COMPREHENSIVE GROUND WATER MONITORING EVALUATION

GENERAL MOTORS CORPORATION - INLAND FISHER GUIDE DIVISION

ELYRIA, OHIO

OHIO ENVIRONMENTAL PROTECTION AGENCY

FIGURE 4 - MONITOR WELL LOCATION MAP
"AND RENUMBERING OF WELLS"

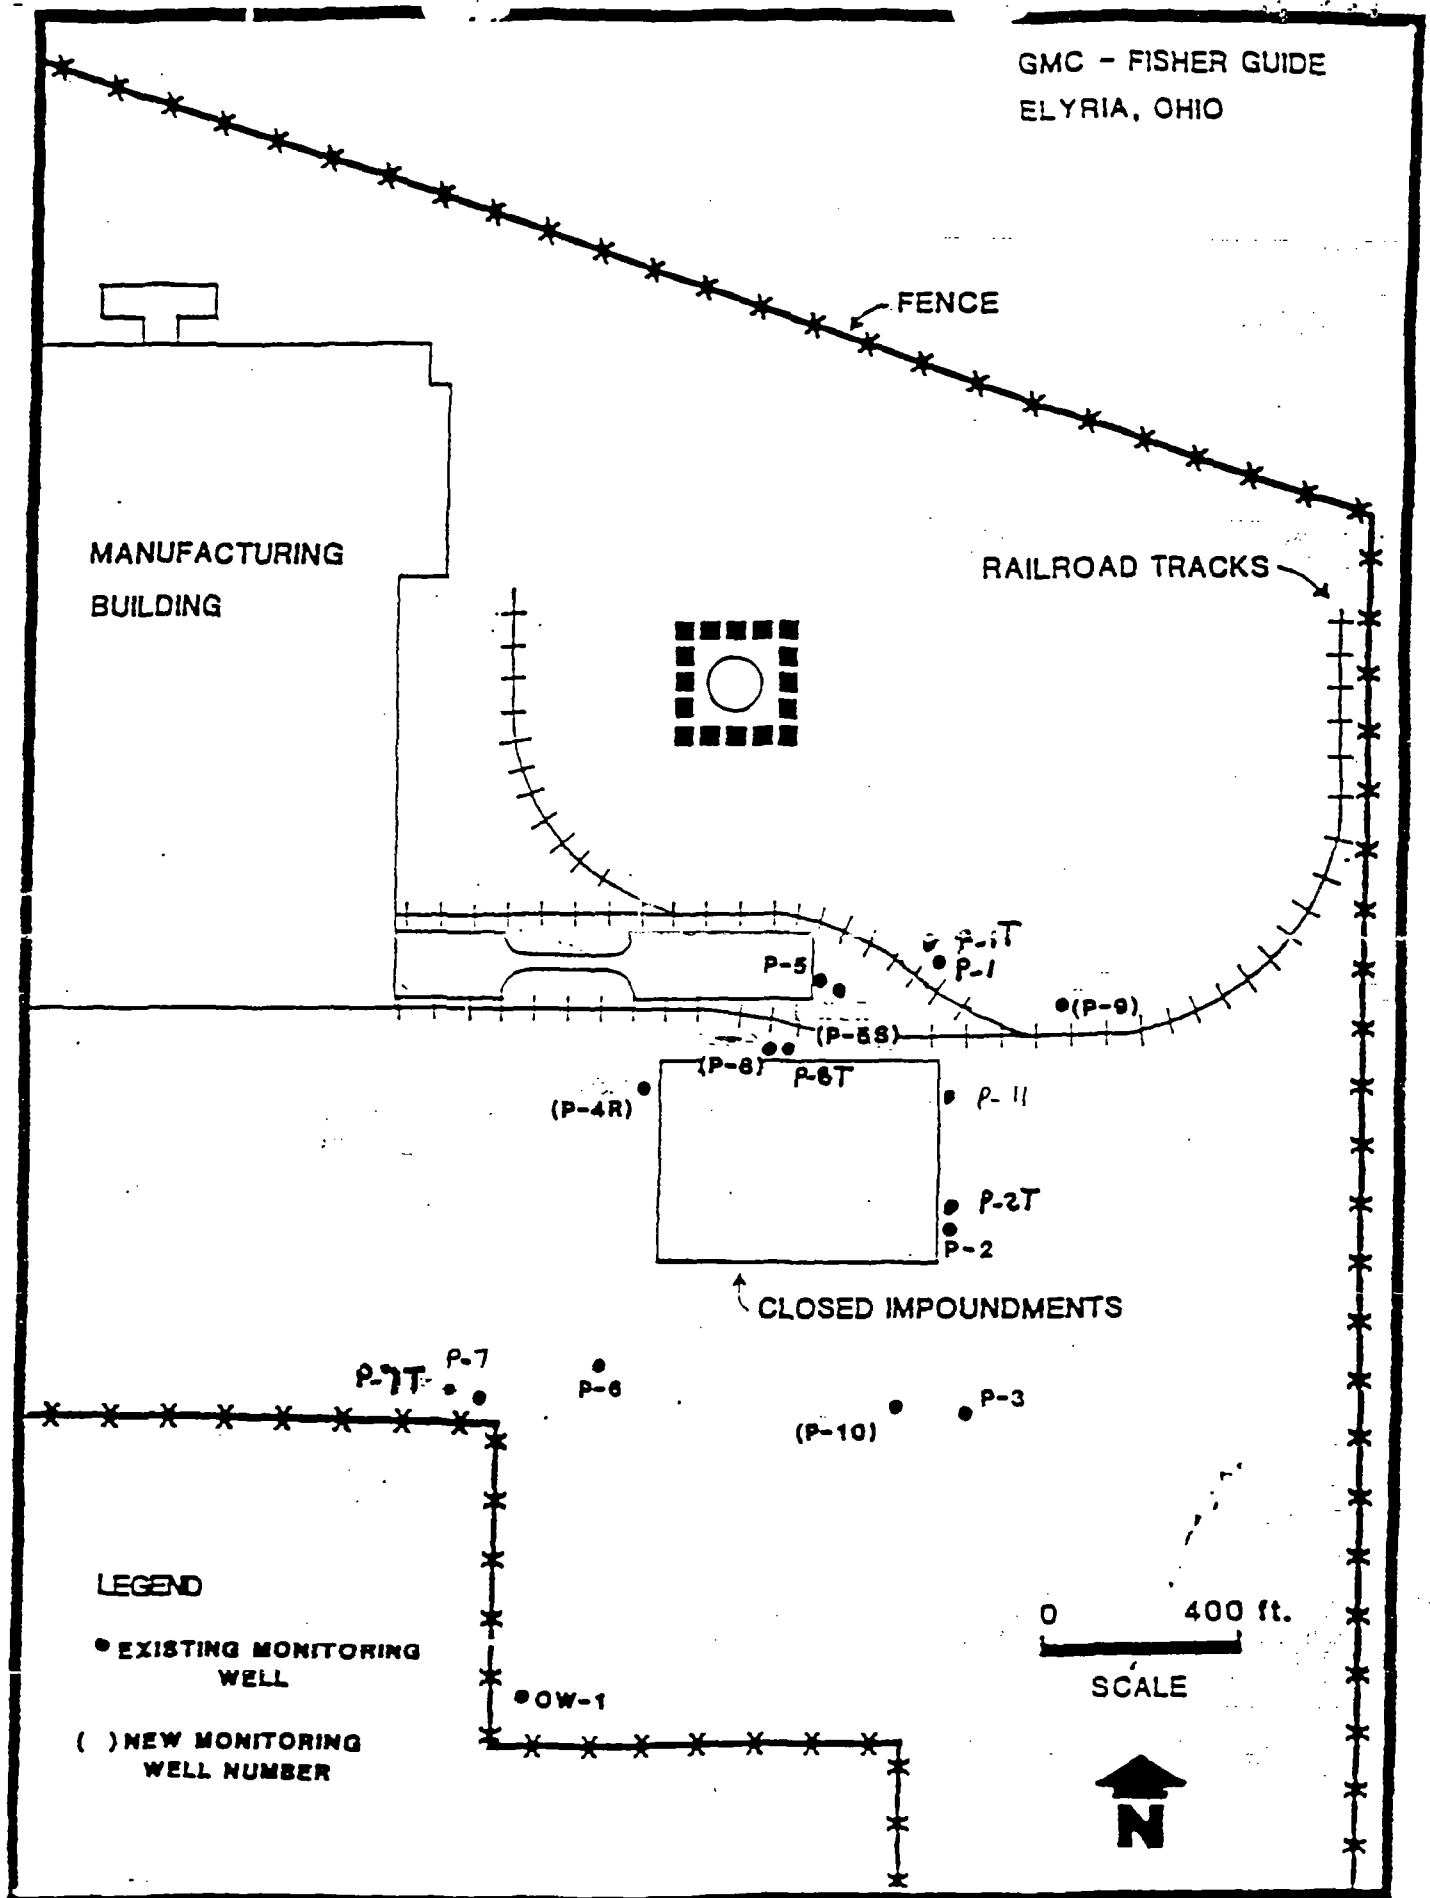
During the CME inspection wells were found located as the map illustrated in Figures 4 and 5, except for monitoring wells P-7 and P-7T were located west of a fence line that extends from monitoring OW-1 to the plant (Parcel A) fence.

It should be noted that monitoring well P-11 was shown at two different locations on map Figures 4, 5, 7, and 13 (References # 6,7). However, according to Map Figure 17, the most recent map, and Philip R. Kienle, of GMC Fisher monitoring well P-11 is located east of the site between P-1 and P-2 as mentioned in the monitoring well location section of this report.

FIGURE 16 WATER TABLE ELEVATION CONTOUR MAP
AUGUST 1988

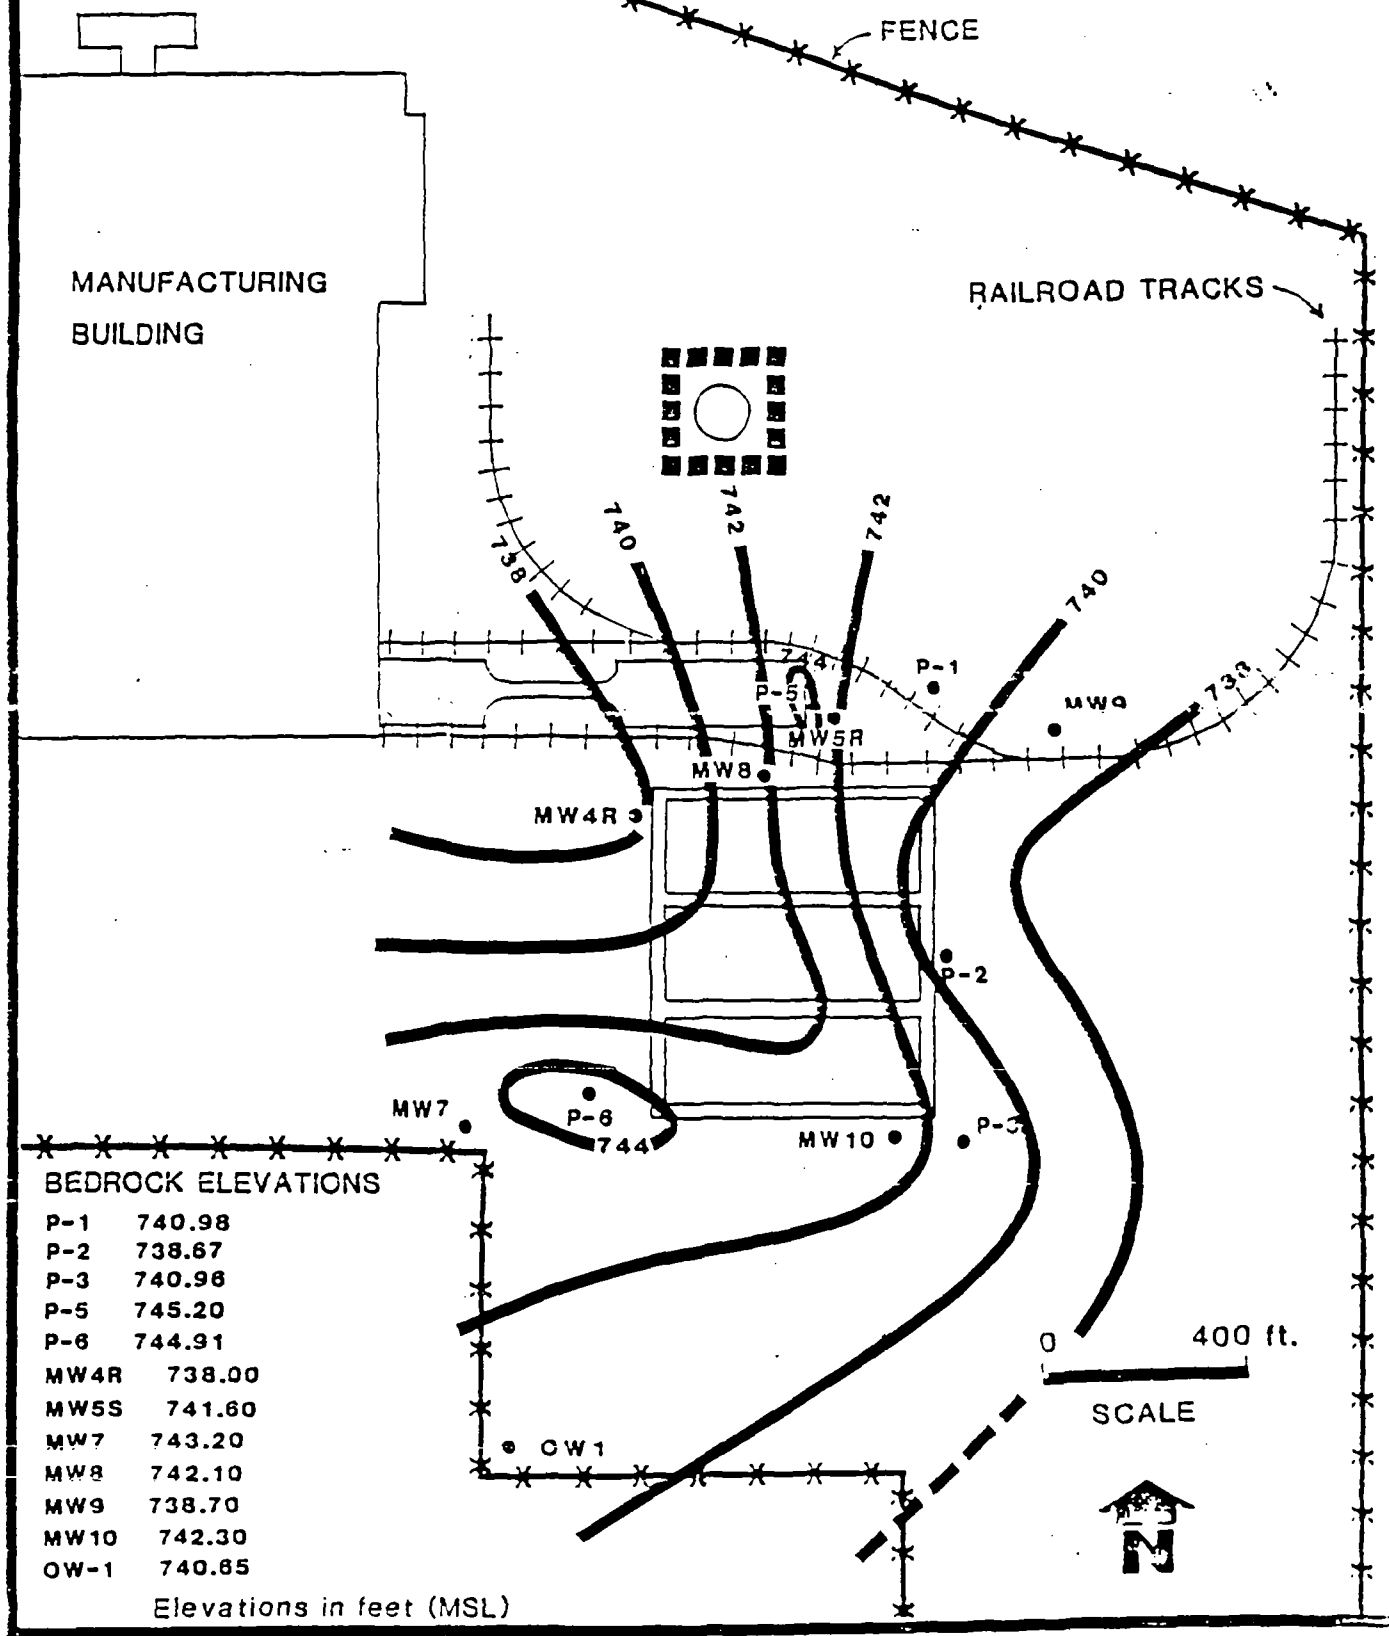
In August 1988, ground water elevations were obtained and are presented in Figure 16. The map demonstrates that the on-site hazardous waste landfill has changed ground water flow direction to the east-southeast as interpreted by Ohio EPA. Ohio EPA's conclusion does not agree with GMC Fisher in their November 1988 Part B-Closure Application, that ground water flow is to the east-northeast. To determine the consistency of the east-southeast direction of ground water, additional measurements and potentiometric surface maps are needed for all the wells.

FIGURE 16A - Potentiometric Surface Map for November 1989
Produced by Ahmed A. Mustafa, Ohio EPA

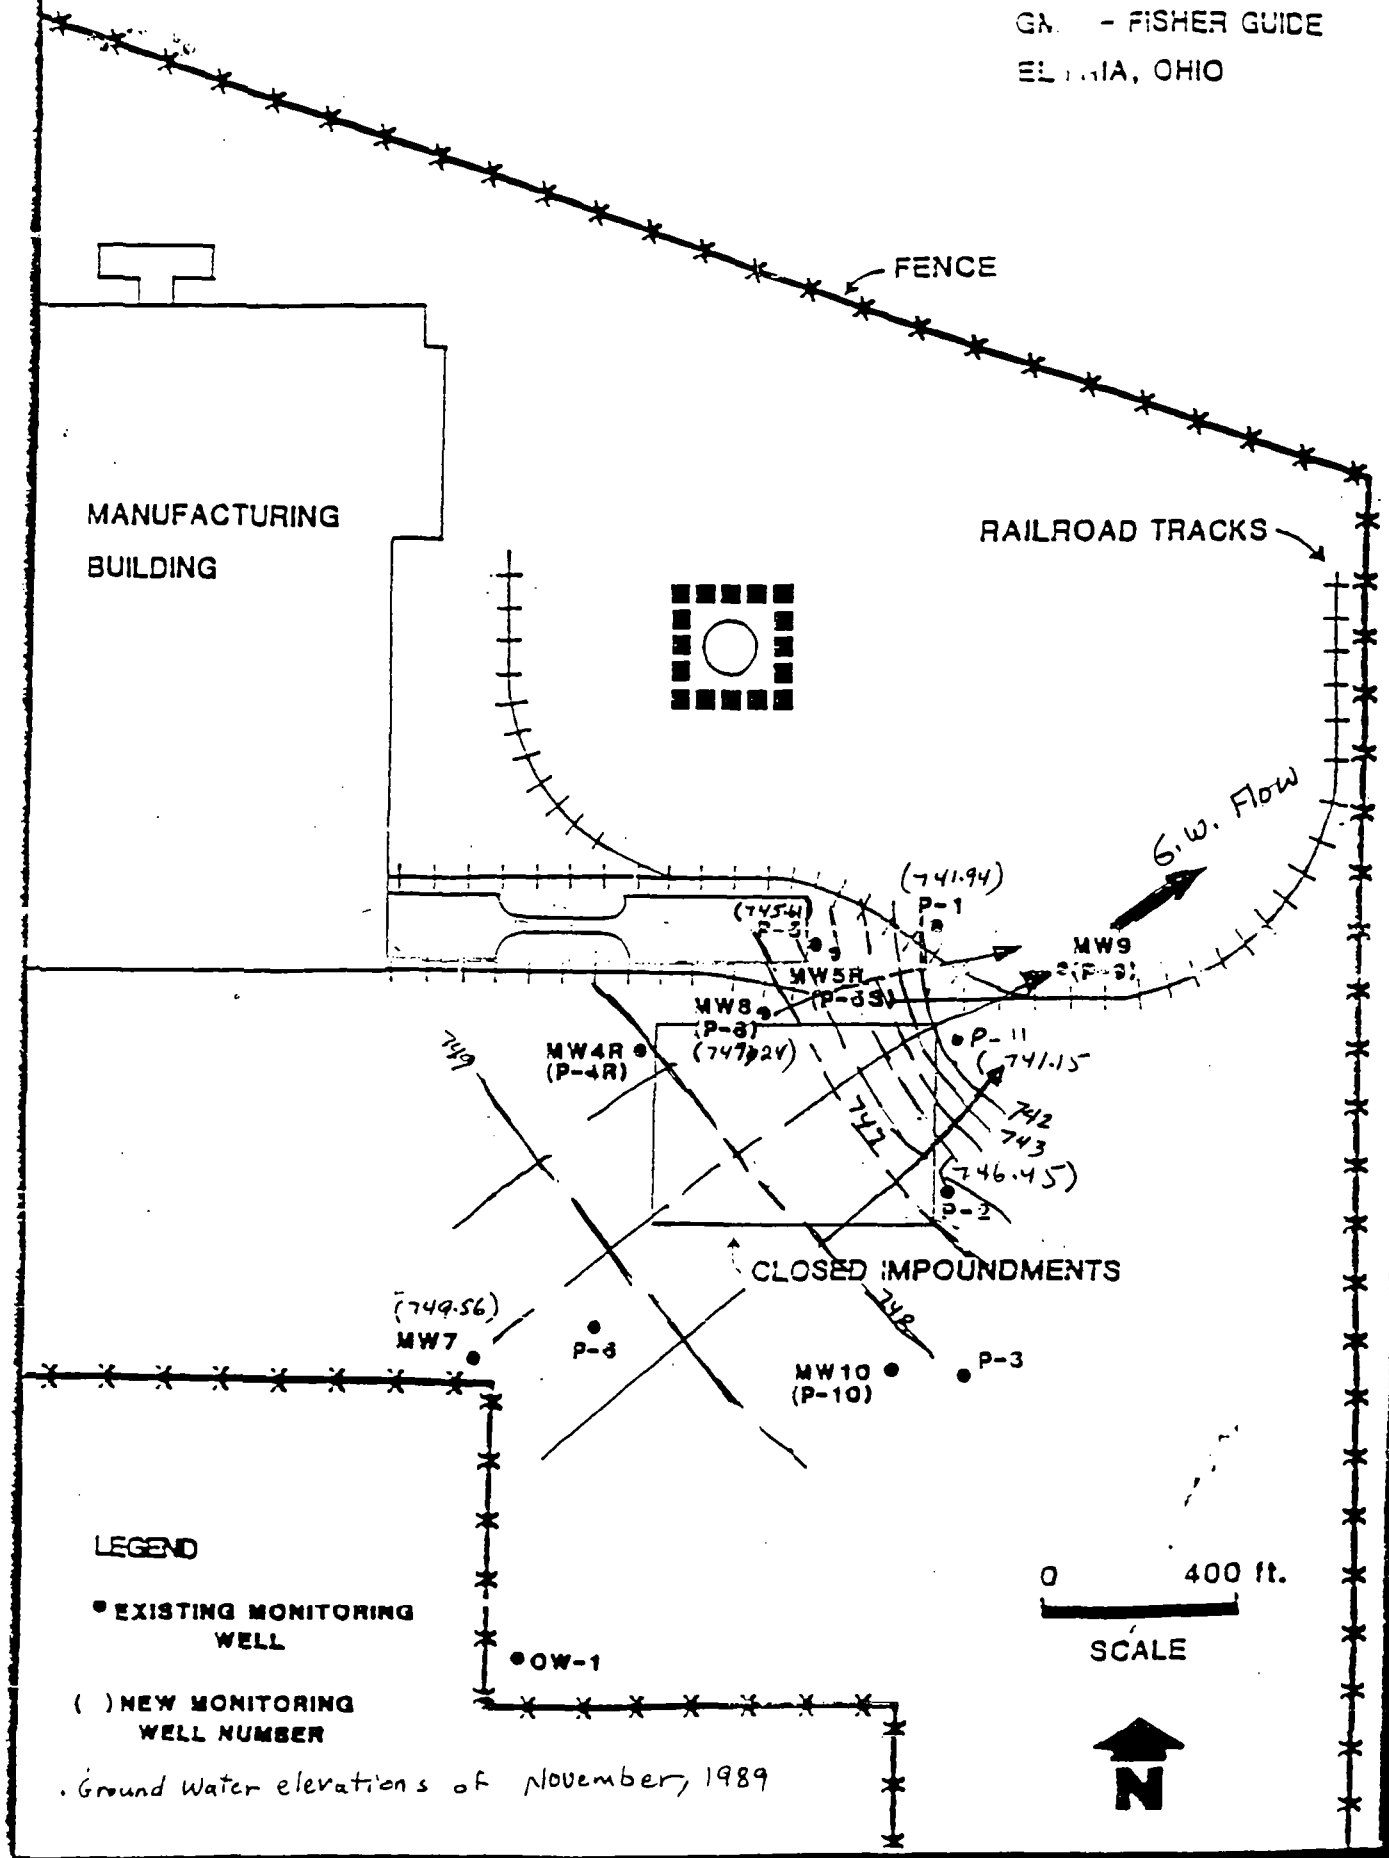
An Ohio EPA potentiometric surface maps (Figure 16A, 16B and 16C), indicate that ground water is moving in a northeastern direction. These maps should include all the wells that exist on site and should be in elevations above mean seal level and not depths in feet to water from the top of casing.
